Work Order ID 90193

Item Name: Crosstube Mid Aft

DART AEROSPACE LTD		Work Order:	90193
Description: Crosstube Mid Aft (206L)		Part Number:	D206-667-207
Inspection Dwg: D206-667-247 Rev: A		Page 1 of 1

DART AEROSPACE LTD HAWKESBURY, ONTARIO, CANADA	
DRAWING NO. D206-667-247	REV. A SHEET 1 OF 4
TITLE CROSSTUBE ASSY (206L MID AFT)	SCALE NTS

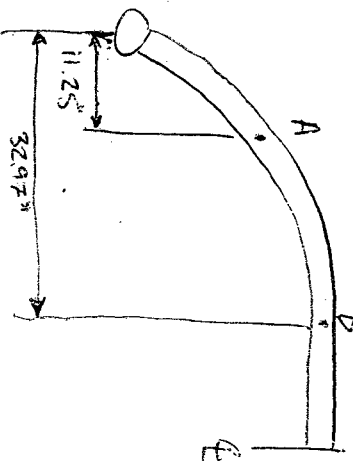
PURPOSE:

REPLACE MAGNOBOND WITH PROSEAL.

NOTE 12 & 15, SHEET 1 IS AMENDED AS FOLLOWS:

IS:

Item	Qty -247	Part Number	Description
9	A/R	PROSEAL 890 B-2	SEALANT, AMS-S-8802 CLASS B-2

IS:

- 12) TO INSTALL D2892-1 SUPPORT: ABRABE MATING SURFACE OF SUPPORT AND CROSSTUBE WITH 180-GRIT SANDPAPER AND REMOVE RESIDUE WITH MEK (OR EQUIVALENT). APPLY A 0.04" TO 0.07" THICK LAYER OF PROSEAL 890 CLASS B-2 (OR AMS-S-8802 CLASS B-2) SEALANT TO MATING SURFACE OF SUPPORT.
- 15) TORQUE CLAMPS 80 TO 100 IN-LB. ENSURE AT LEAST 1.5 THREADS SHOWING IN SAFETY AND THAT NUT HAS NOT BOTTOMED-OUT AFTER TORQUING. **PRIOR TO PACKAGING, RE-CHECK TORQUE ON CLAMPS AFTER PROSEAL 890 SEALANT HAS CURED FOR 72 HOURS.**
